Improved Pro Series® Cylinders

CYLINDER AND KEY ENHANCEMENTS

NEW KEYS ROUND ON THE BOTTOM

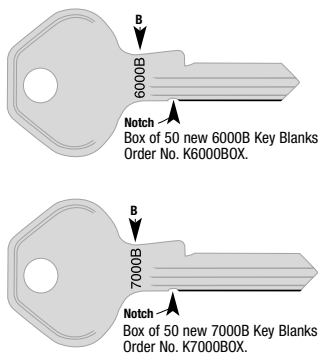
The keys affected are the 6000 and 7000. Rounded bottom keys stamped 6000B and 7000B have replaced them.

Avoid duplicating an old style key onto a new “B” style round-back blank. Cuts will be .0125" too deep. Use codes below to cut.

Cut	Root Depth
0	.271"
1	.256"
2	.240"
3	.225"
4	.209"
5	.194"
6	.178"
7	.163"

OLD KEYS FLAT ON THE BOTTOM

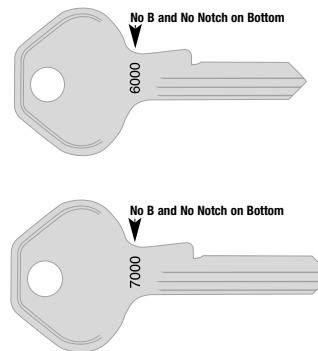
Avoid duplicating a “B” round-back key onto an old style blank. Cuts will be .0125" too shallow. Use codes below to cut.

Original blanks no longer available.

Cut	Root Depth
0	.2845"
1	.2690"
2	.2535"
3	.2380"
4	.2225"
5	.2070"
6	.1915"
7	.1760"
